DEPARTMENT OF THE ARMY

SUBJECT: FY17 Periodic Inspection of Completed Works, Flood Risk Management Project,
Genesee River, Wellsville, New York (09/27/17)

Transmitted herewith is the FY17 Inspection of Completed Works (ICW) Periodic Inspection report for the Flood Risk Management (FRM) Project at Genesee River, Wellsville, New York. Thank you for your agency's participation in this inspection. In accordance with USACE – Headquarters guidance, the rating for this project as determined by the current inspection is **"UNACCEPTABLE" (U)**. This project is **"ACTIVE"** in the USACE Rehabilitation Program.

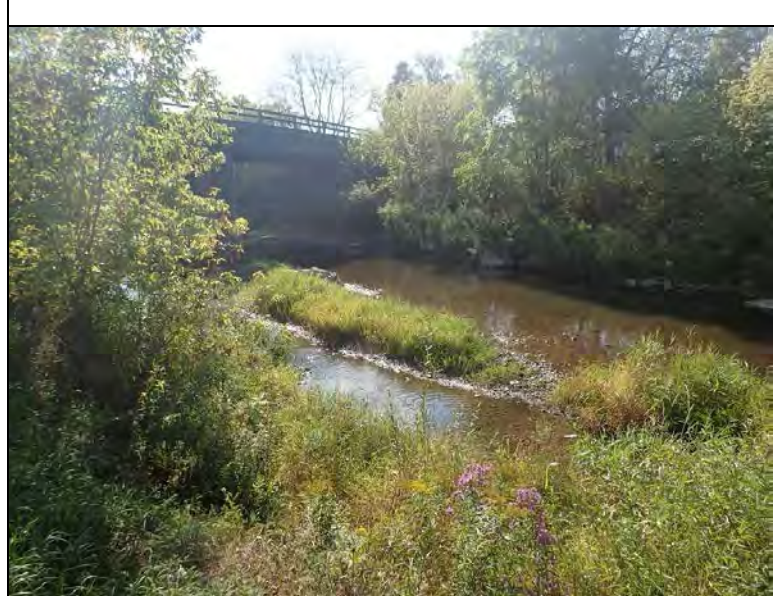
<p>Inspect ID: N21R_2017_p_0005 Title: USACE_CELRB_N21R_2017_p_0005_1.jpg Rated Item: 2. Shoaling (sediment deposition) Caption: Rating: Minimally Acceptable; Remarks: Shoaling (S-14) on right bank from 200' upstream of drop structure to upstream project limit. (Dyke Creek).; Action: Remove shoaling.; Station_1: 35+00; Station_2: 35+00</p>
	<p>Inspect ID: N21R_2017_p_0015 Title: USACE_CELRB_N21R_2017_p_0015_1.jpg Rated Item: 2. Shoaling (sediment deposition) Caption: Rating: Minimally Acceptable; Remarks: Minor shoal (S-15) in center of channel 100' downstream of drop structure to 200' downstream of drop structure. (Dyke Creek); Action: Remove shoal.; Station_1: 34+00</p>

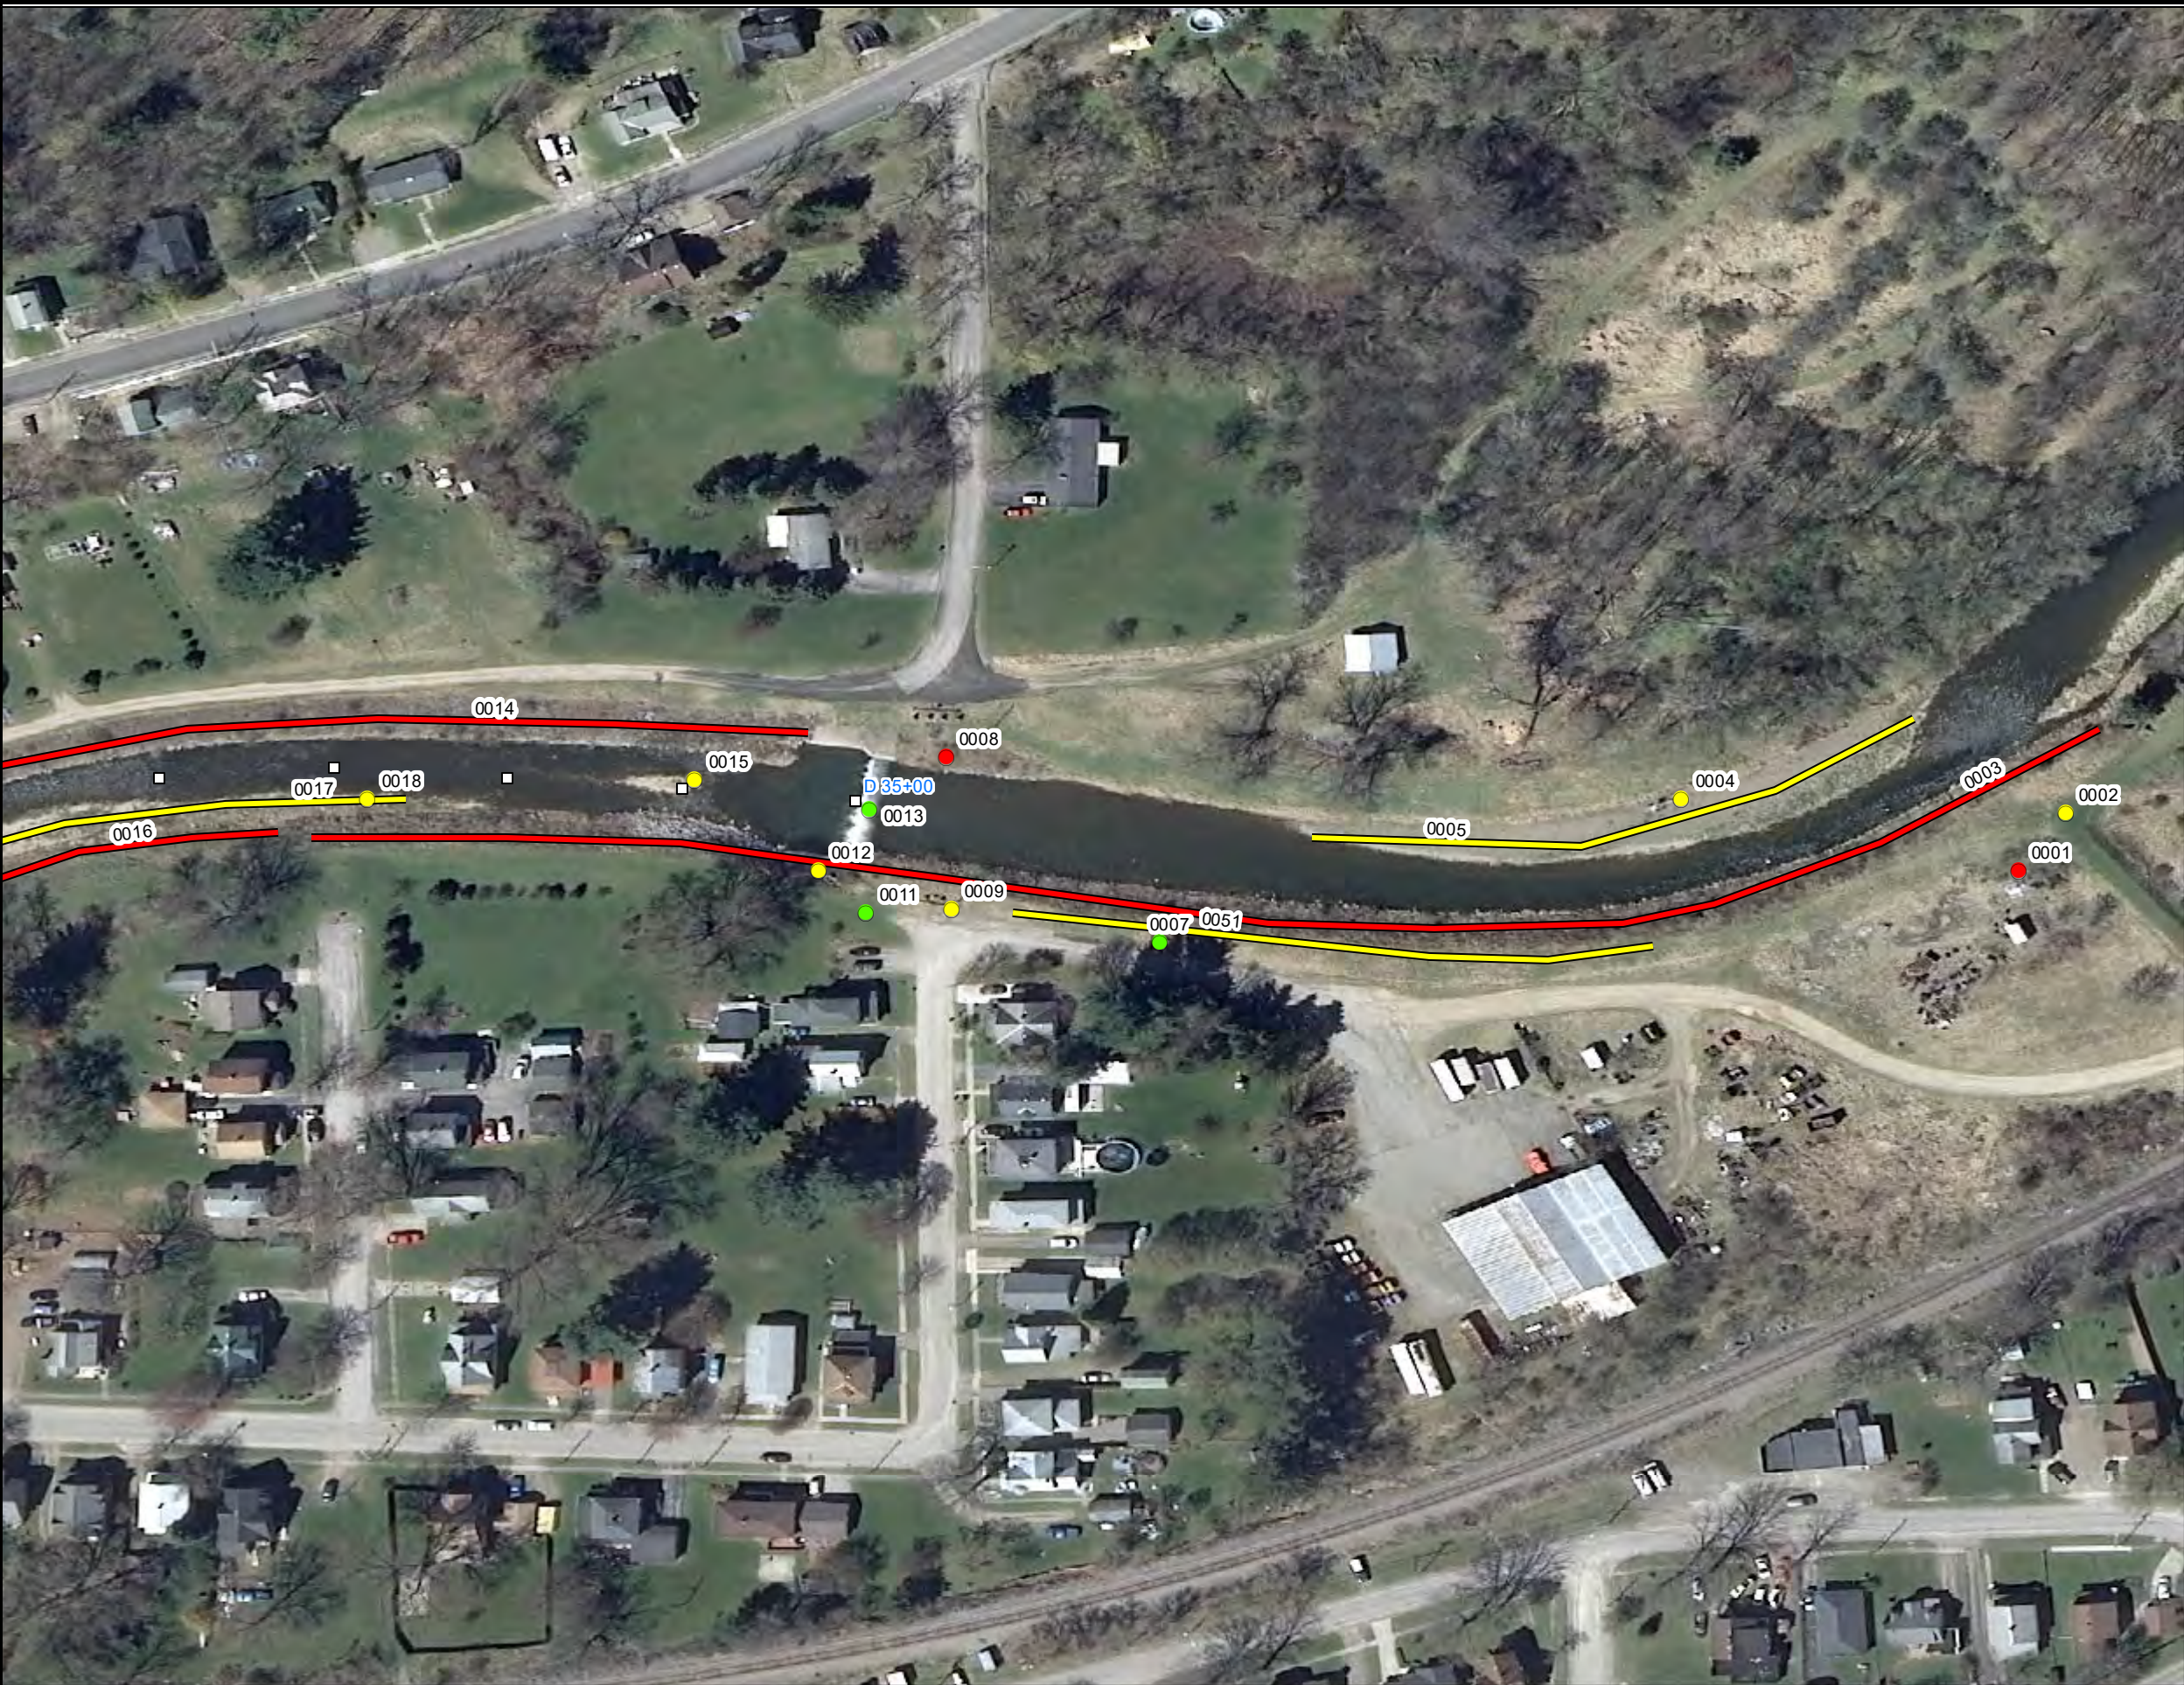
<p>Inspect ID: N21R_2017_p_0035 Title: USACE_CELRB_N21R_2017_p_0035_1.jpg Rated Item: 10. Riprap Revetments & Banks Caption: Rating: Unacceptable; Remarks: Significant trees and vegetation in riprap on both banks just downstream of Main Street bridge. (Dyke Creek); Action: Remove trees and vegetation from riprap.; Station_1: 17+00</p>
